VERIFICATION OF INTERIM PERFORMANCE INDICATORS UNDER THE GUYANA-NORWAY REDD+ PARTNERSHIP

Monitoring Period:
1 October 2009 to 30 September 2010 – Year 1

REPORT No. 2011-9107

REVISION No. 02

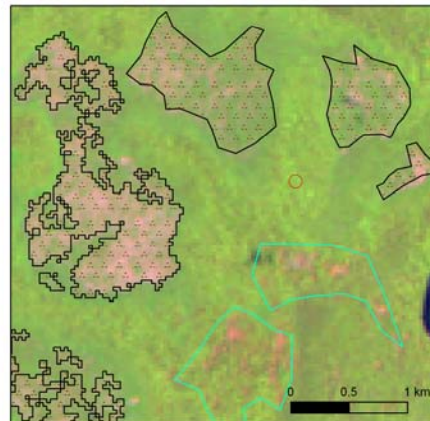
Section 7.0. We fully understand and agree that areas under SFM that adhere to forestry code practice should not be considered deforested. However, it could be useful if possible to see data on the extent of the area that currently has crown cover below the 30% limit without being classified as deforested.

RP: *Generally the spatial pattern of selective harvesting is discontinuous, so it is difficult to map these areas individually using the Landsat. The approach taken was to map the spatial extent of the harvest area rather than each area individually.*

The following example shows an area where harvesting has occurred and the general extent of the activity. For reference a 1 ha circle is also shown. This represents the MMU. Non-forest areas are also identified. These areas were non-forest as at 1990, so do not constitute change.
